# CR Mated Test Fixture Insertion Loss (Comment #357)

Howard Heck, Jason Ellison, Megha  
Shanbhag, Nathan Tracy

Week of Sept 15, 2025

Figure 179A-1—Host-Nominal to Host-Nominal, Cable assembly, and test fixture insertion loss at 53.125 GHz

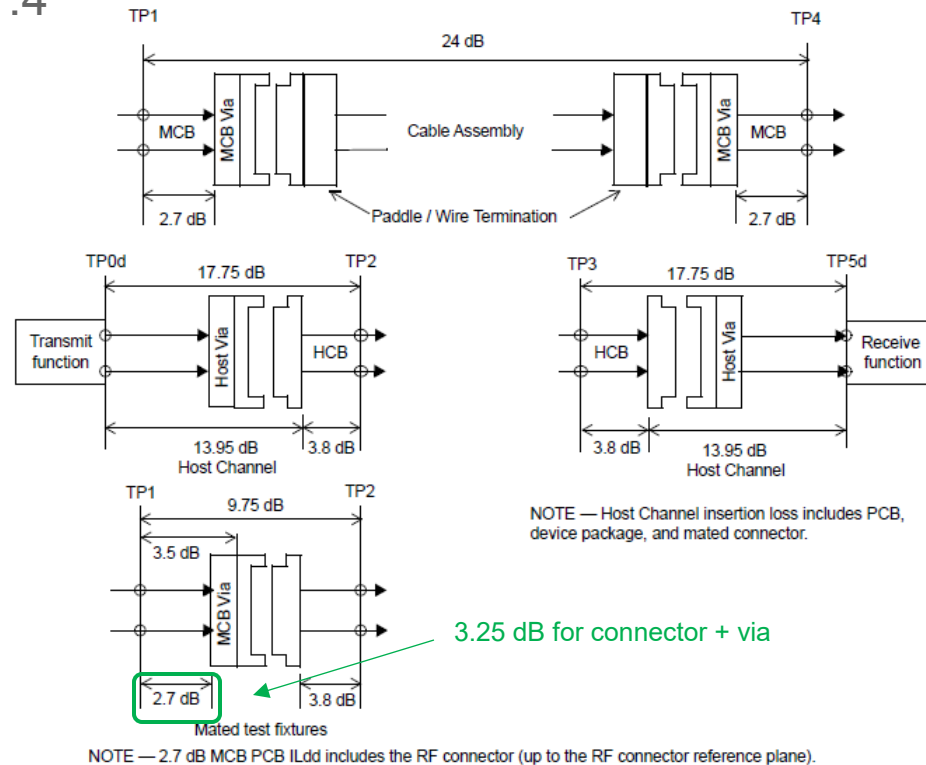
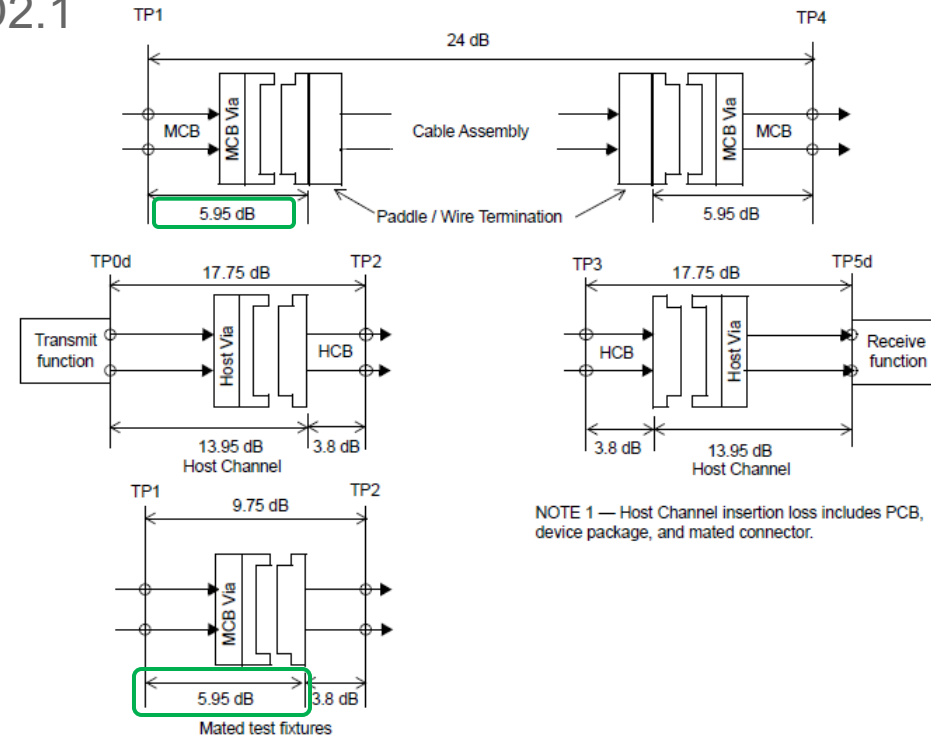
- Comment #140 against D1.4 resulted in a change to Figure 179A-1 that resulted in the loss of the MCB PCB and the via+connector being lumped into a single value.
- This has the unintended consequence of requiring adjustment to the MCB PCB design to compensate for any difference in via+connector insertion loss from the amount allocated to it prior to D1.5, which can increase the amount of MCB trace loss that must be included in a TP1-TP4 cable assembly measurement.
- To address the problem, we propose change Figure 179A-1 by either
  1. Reverting to the version that was in D1.4 (as proposed in D2.0 comment #289).
  2. (Preferred) Increasing the HCB loss (TP2-to-connector) to from 3.8 dB to 4.8 dB while reducing the MCB loss (TP1-to-connector 'far side') from 5.95 to 4.95 dB.

The recommended maximum differential insertion loss (TP0d-to-TP2) or (TP3-to-TP5d) are consistent with the host channels and an assumed mated connector insertion loss of 2.45 dB.

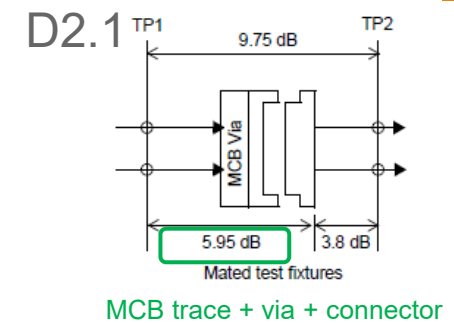
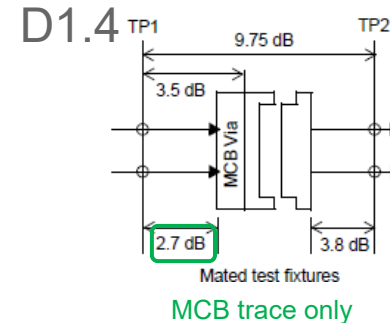
- TP1-TP2 = 9.75 dB
- HCB from TP2 to connector = 3.8 dB
- MCB from TP1 to the far side of the connector = 5.95 dB

MCB loss specification therefore includes PCB, PCB via and the via+connector.

- Through D1.4, the MCB loss was specified as PCB only with a value of 2.7 dB, allocating 3.25 dB for the via+connector.
  - Note: Cable assemblies to date have been measured with MCBs designed to the 2.7 dB trace insertion loss.
- Measurement of MTFs are showing via+connector loss to be in the range of 2.25 dB.
  - Since MCB loss specification includes the via+connector, the MCB traces require 1 dB additional loss to compensate for the lower via+connector loss.
  - Based on all drafts since D1.5, all CR cable assemblies should be measured with redesigned MCB's
  - This increases the amount of MCB loss included in a TP1-TP4 cable assembly measurement by 2 dB, effectively reducing cable assembly portion of the loss by 2 dB (2 MCBs in a measurement), compromising the ability to meet the existing TP1-TP4 insertion loss specs. We do not believe this was the intent of the change made in D1.5

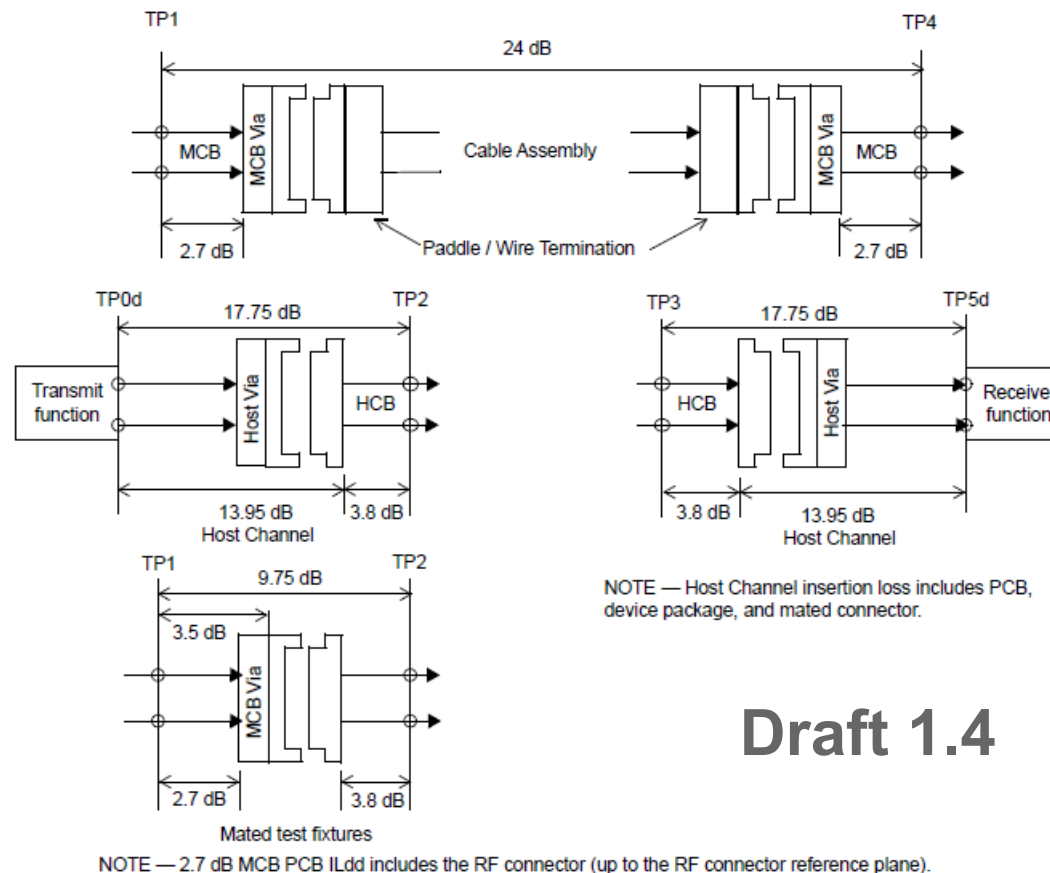
Return to the insertion specification in Figure 179A-1 from Draft 1.4.

The recommended maximum differential insertion loss (TP0d-to-TP2) or (TP3-to-TP5d) are consistent with the host channels and an assumed mated connector insertion loss of 2.45 dB.

Figure 179A-1—Host-Nominal to Host-Nominal, Cable assembly, and test fixture insertion loss at 53.125 GHz

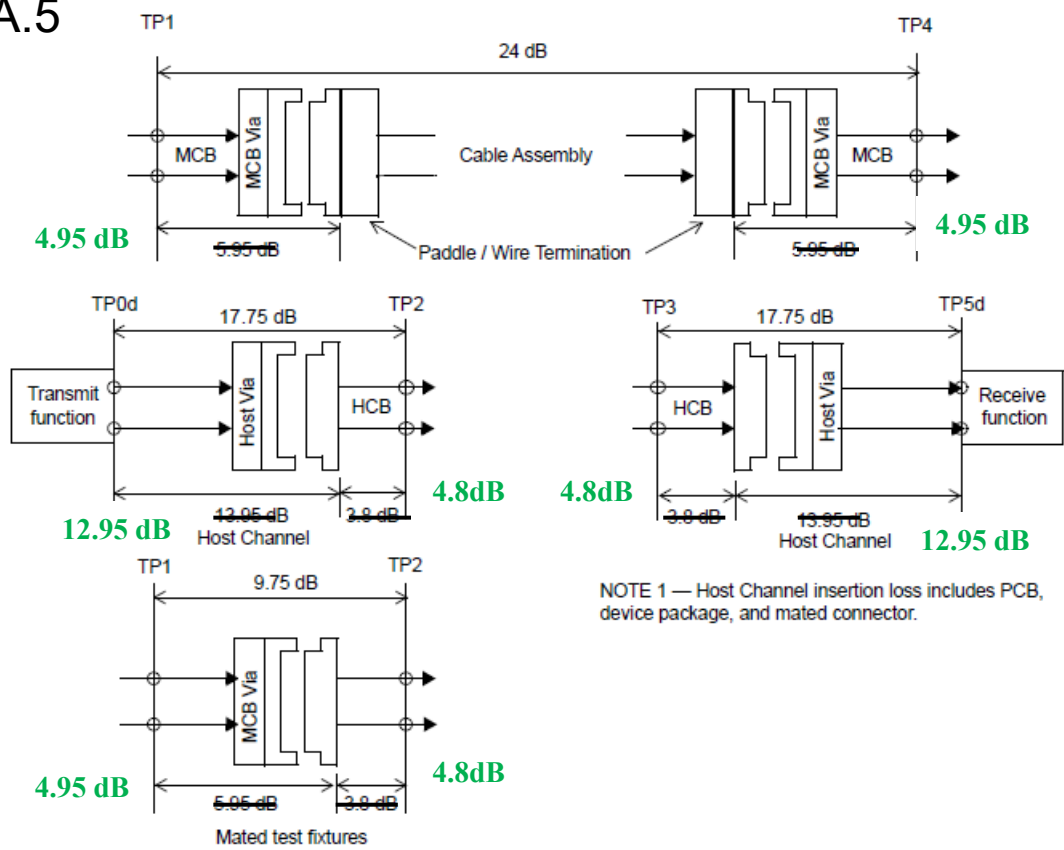
NOTE 2 — The MCB and HCB ILdd allocations include the RF connector (up to the RF connector reference plane).

Figure 179A-2—HN-to-HN Channel Max (TP0d-TP5d) at 53.125 GHz

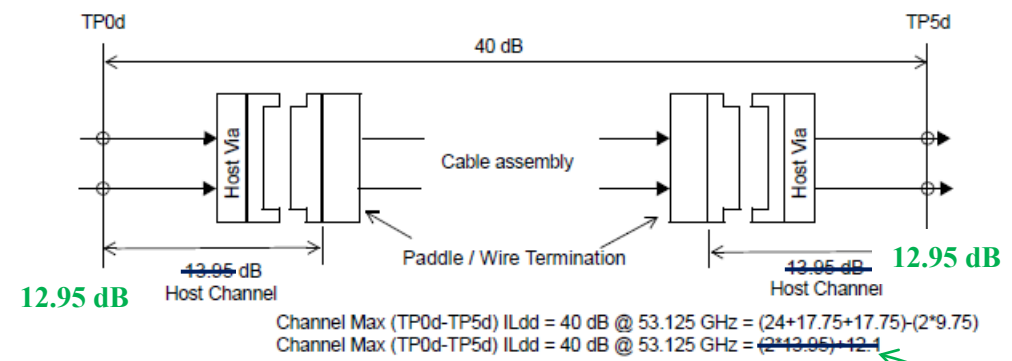
Channel Max (TP0d-TP5d) ILdd = 40 dB @ 53.125 GHz = (2\*12.95)+14.1

Note: The change in host channel loss is due solely to reduce connector loss. Host routing is not affected.
